FACSIMILE TRANSMITTAL

Re: Joe Sio Chevrolet, 914-916 San Pablo Avenue, Albany, California

PHILIP ENVIRONMENTAL	SITE PLAN Joe Sio Chevrolet 914 - 916 San Pablo Avenue Albany, California	Figure 2	
	Reviewed By :	Date :	Project No. 12104 Drawn By: SWW Date: 3/12/93 Drawing No. ASI00102

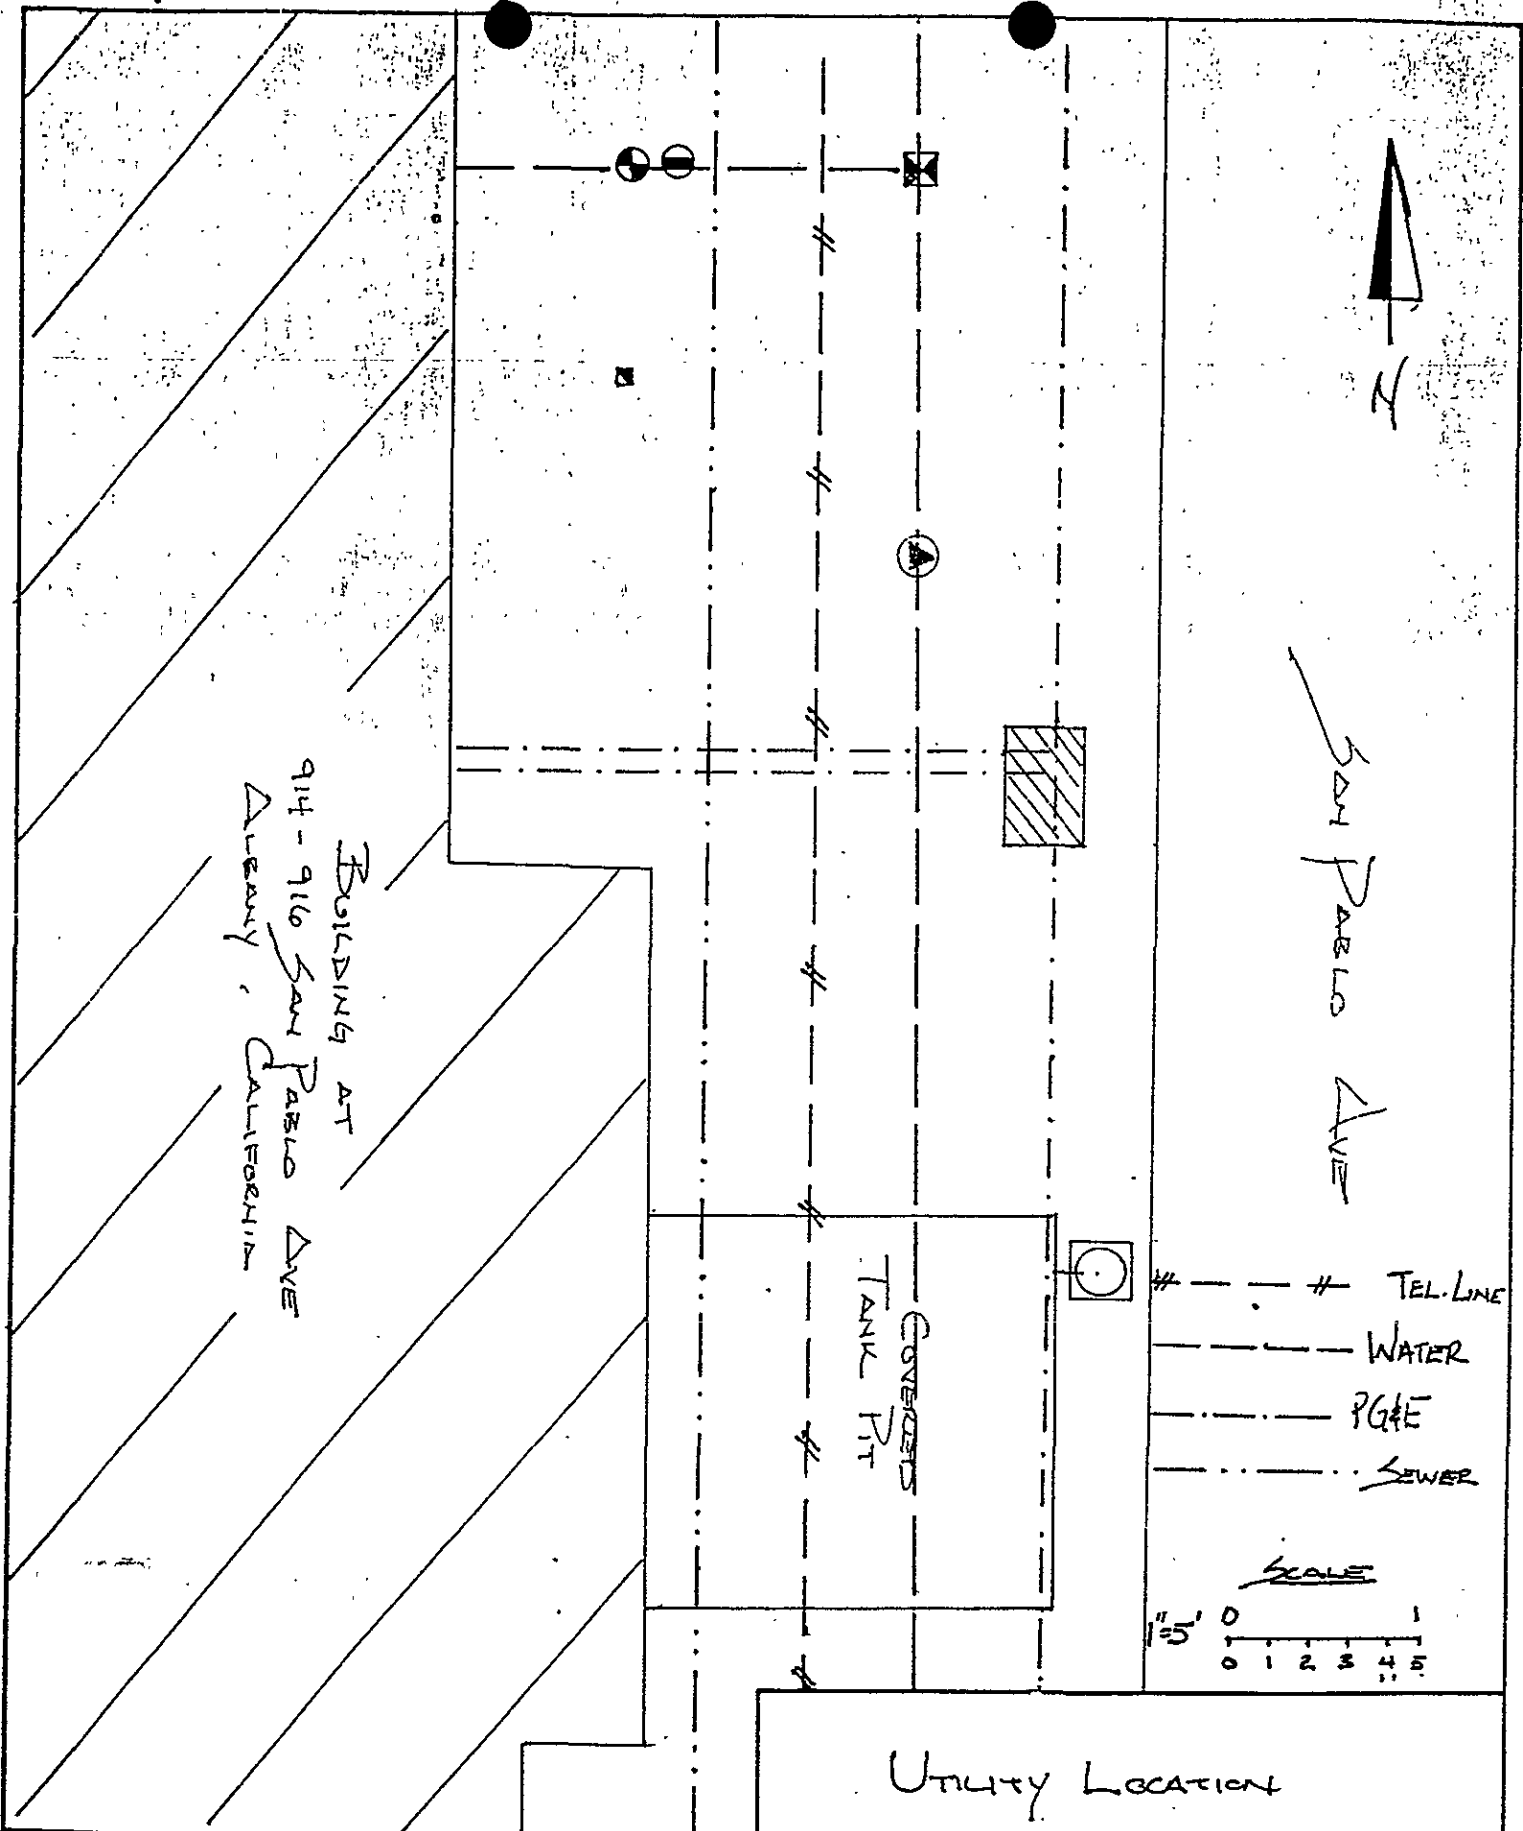
Per my conversation w/ Mr. Rahman on 8/22/96 this well location will be moved between 20 to 40' away from MW1 - gms
